FORM APPROVED
OMB NO. 1004-0135
Expires: July 31, 2010**SUNDRY NOTICES AND REPORTS ON WELLS**
Do not use this form for proposals to drill or to re-enter an abandoned well. Use form 3160-3 (APD) for such proposals.

HORNED VIPER 20 FEDERAL 2H

30-025-41914-00-X1

PECOS DISTRICT CONDITIONS OF APPROVAL

DM100161771-2A

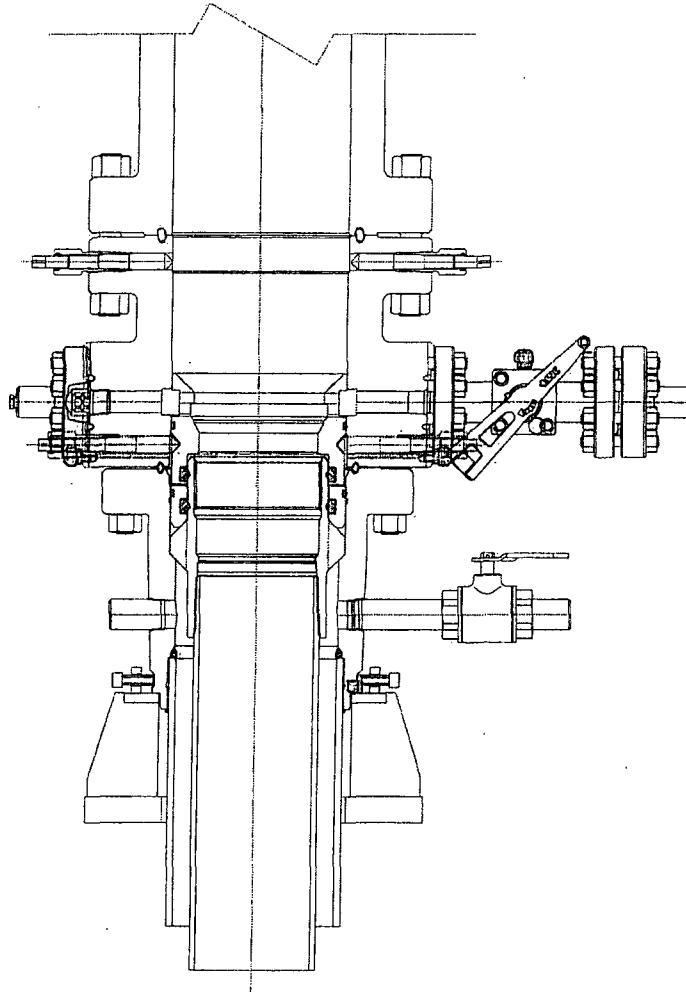
Devon energy requests to use FMC uni-head system. A multibowl wellhead is being used. The BOP will be tested per Onshore Order #2 after installation on the surface casing which will cover testing requirements for a maximum of 30 days. If any seal subject to test pressure is broken the system must be tested. Devon proposes using a multi-bowl wellhead assembly (FMC Uni-head). This assembly will only be tested when installed on the surface casing. Minimum working pressure of the blowout preventer (BOP) and related equipment (BOPE) required for drilling below the surface casing shall be 3000 (3M) psi. Wellhead will be installed by FMC's representatives. If the welding is performed by a third party, the FMC's representative will monitor the temperature to verify that it does not exceed the maximum temperature of the seal. FMC representative will install the test plug for the initial BOP test. FMC will install a solid steel body pack-off to completely isolate the lower head after cementing intermediate casing. After installation of the pack-off, the pack-off and the lower flange will be tested to 5M, as shown on the attached schematic. Everything above the

pack-off will not have been altered whatsoever from the initial nipple up. Therefore the BOP components will not be retested at that time. If the cement does not circulate and one inch operations would have been possible with a standard wellhead, the well head will be cut and top out operations will be conducted. Devon will pressure test all seals above and below the mandrel (but still above the casing) to full working pressure rating. Devon will test the casing to 0.22 psi/ft or 1500 psi, whichever is greater, as per Onshore Order #2. After running the 13-3/8" surface casing, a 13-5/8" BOP/BOPE system with a minimum rating of 3M will be installed on the FMC Uni-head wellhead system and will undergo a 250 psi low pressure test followed by a 3,000 psi high pressure test. The 3,000 psi high and 250 psi low test will cover testing requirements a maximum of 30 days, as per Onshore Order #2. If the well is not complete within 30 days of this BOP test, another full BOP test will be conducted, as per Onshore Order #2. After running the 9-5/8" intermediate casing with a mandrel hanger, the 13-5/8" BOP/BOPE system with a minimum rating of 3M will already be installed on the FMC Uni-head. The pipe rams will be operated and checked each 24 hour period and each time the drill pipe is out of the hole. These tests will be logged in the daily driller's log. A 2" kill line and 3" choke line will be incorporated into the drilling spool below the ram BOP. In addition to the rams and annular preventer, additional BOP accessories include a kelly cock, floor safety valve, choke lines, and choke manifold rated at 3,000 psi WP.

See attached BOP and multi-bowl schematics.

3. Operator has proposed a multi-bowl wellhead assembly. This assembly will only be tested when installed on the surface casing. Minimum working pressure of the blowout preventer (BOP) and related equipment (BOPE) required for drilling below the surface casing shoe shall be 3000 (3M) psi.

- a. Wellhead shall be installed by manufacturer's representatives, submit documentation with subsequent sundry.
 - b. If the welding is performed by a third party, the manufacturer's representative shall monitor the temperature to verify that it does not exceed the maximum temperature of the seal.

- c. Manufacturer representative shall install the test plug for the initial BOP test.
 - d. Operator shall perform the intermediate casing integrity test to 70 % of the casing burst. This will test the multi-bowl seals.

- e. If the cement does not circulate and one inch operations would have been possible with a standard wellhead, the well head shall be cut off, cementing operations performed and another wellhead installed.

FMC Technologies
DRAWING NUMBER
DM100161771-2B

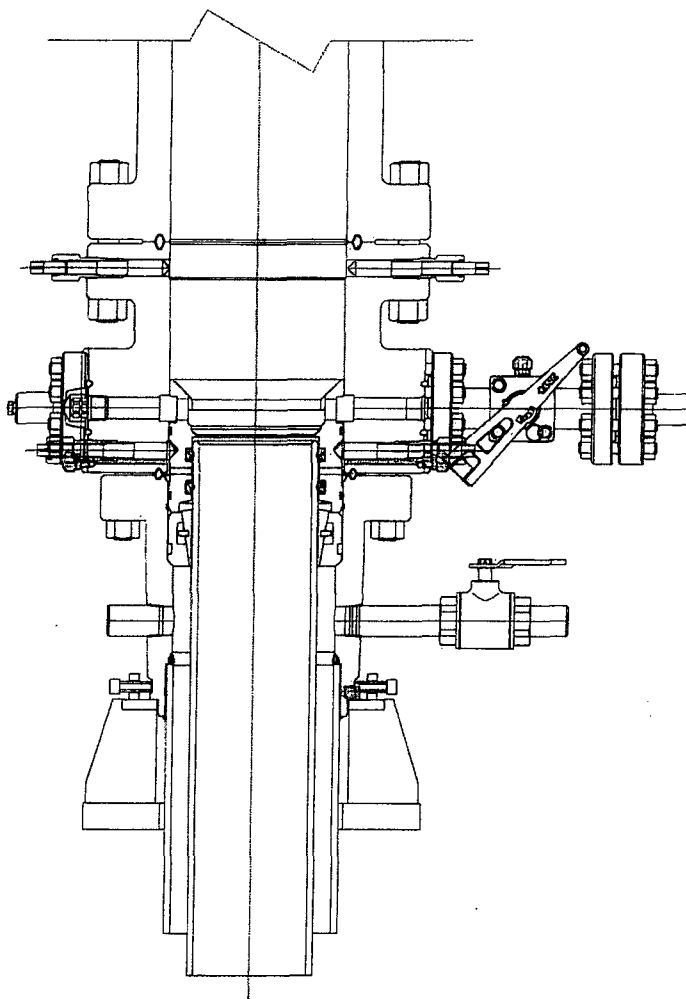
CONTINGENCY MODE
